# PLANNING BOARD MEETING

c. Project: Site Plan – Dandy Mini Mart – Convenience (Mini) Mart

This is our response to the comments provided on June 10, 2022, for the above-referenced project. The following is an item-by-item response, numbered in accordance with your original comments.

**TRUCK PATH FOR FUEL AND PARKING FROM EAST ENTRANCE**

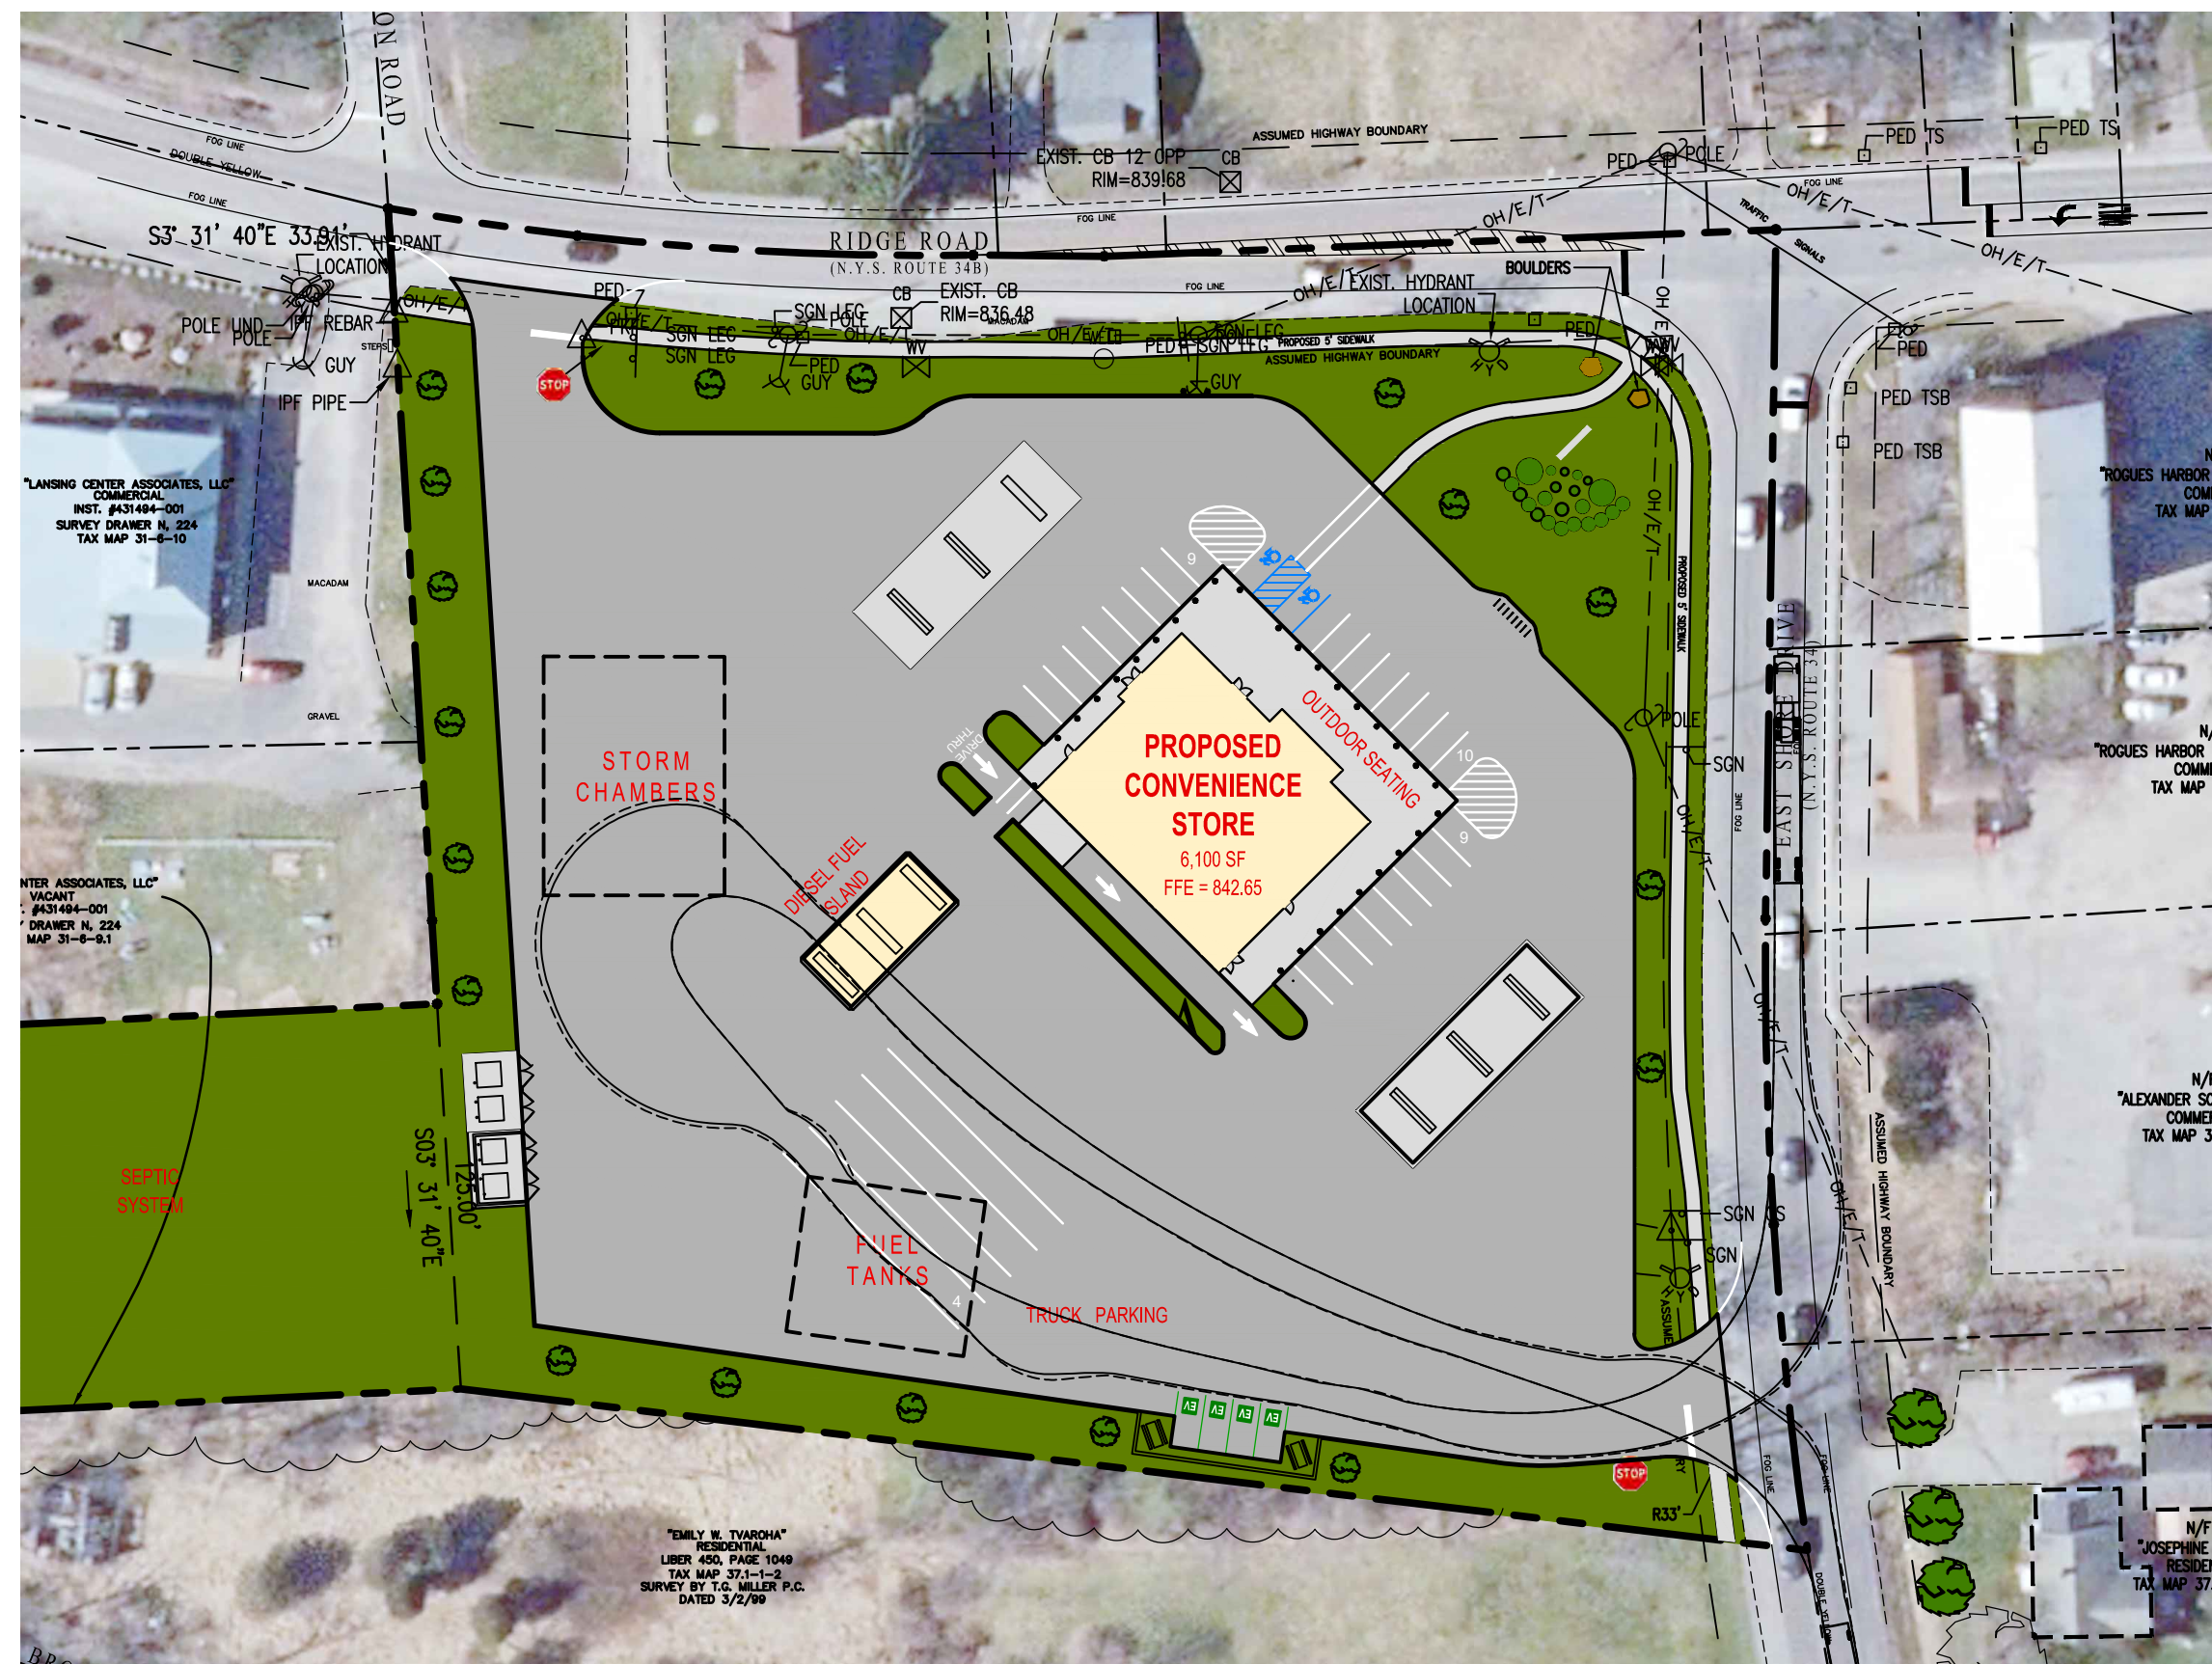
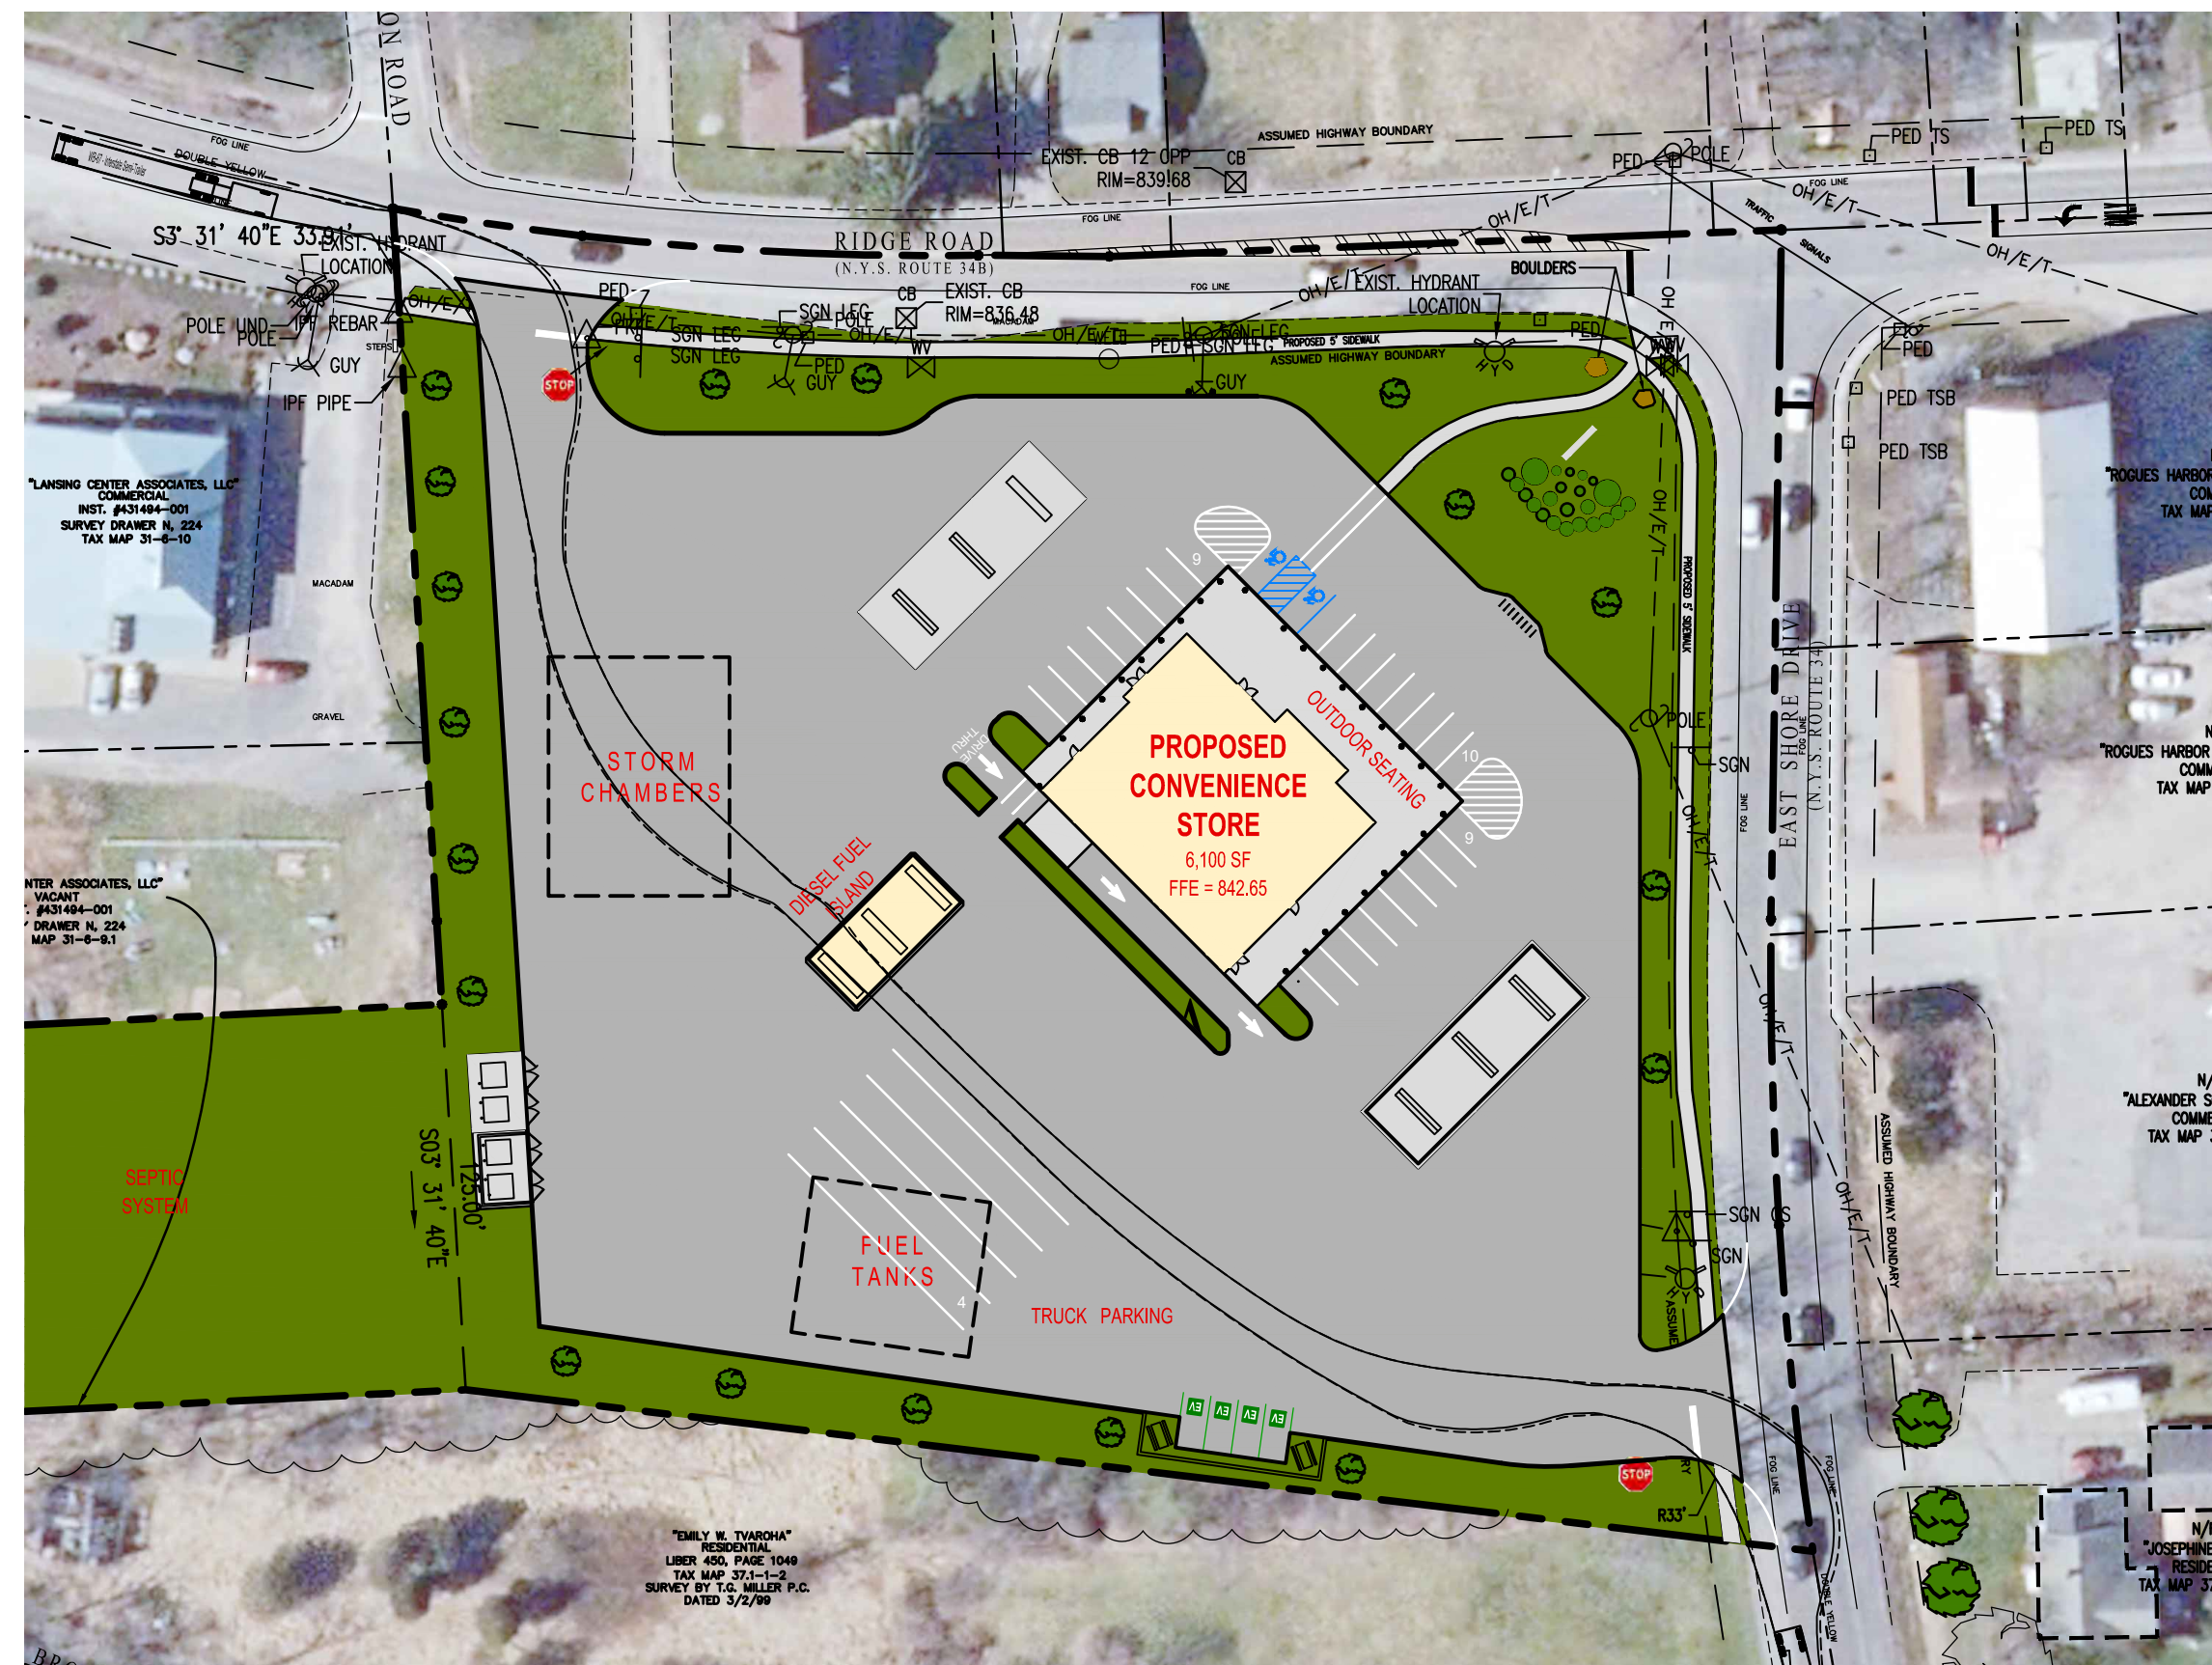
*C5 Sheet C19 is labelled as “truck turning plan”, there do not appear to be any turning movements shown on the plans.*

**R5 Please see revised Plan Sheets C18 and C19 for truck turning and passenger vehicle turning movements.**
